Regulation No. XXX

UNIFORM PROVISIONS CONCERNING THE APPROVAL OF I EMERGENCY CALL DEVICES (AECD) II VEHICLES WITH REGARD TO THE INSTALLATION OF AN AECD OF AN APPROVED TYPE III VEHICLES WITH REGARD TO THEIR AECS

Annex 5

Test method for navigation solution (paragraphs 6.2. and 16.3.)

Figure 1: Open sky definition

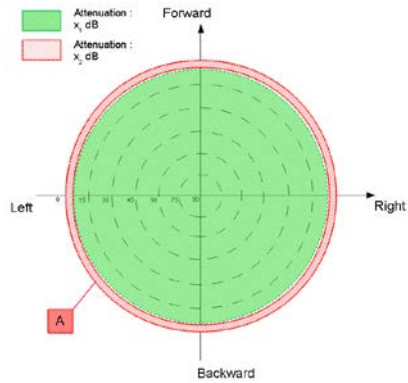
Commenté [110]: DENSO: Please allow to attenuate or switch off for testing – due to realistic test equipment support.
Accepted

Figure 3: Urban canyon definition

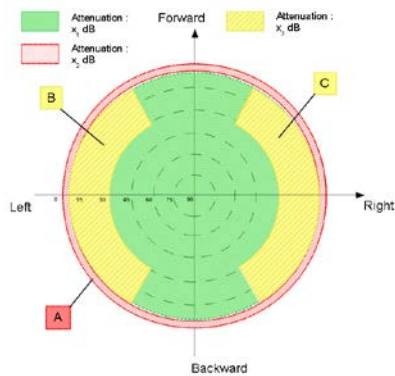
Commenté [121]: DENSO: Please allow to attenuate or switch off for testing – due to realistic test equipment support. (approx. -140 dB – 40dB=-180dB, out of range of typical test equipment – to switch OFF is realistic)

Partially accepted. It is a more realistic scenario as it is right now (-40 dbm).

Figure 4 – Diagram of path calibration

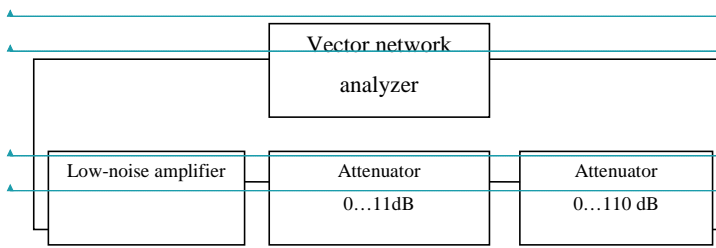
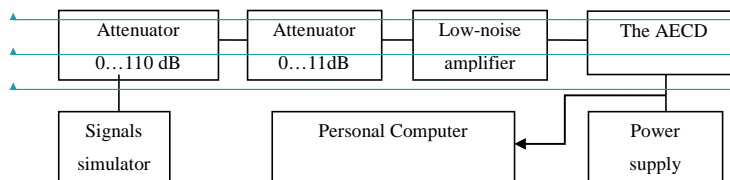
Commenté [128]: DENSO: we feel that the LNA should be located next to the Signal simulator (similar to figure 5 in AECS-07-13e document)
>> Please confirm?

Accepted
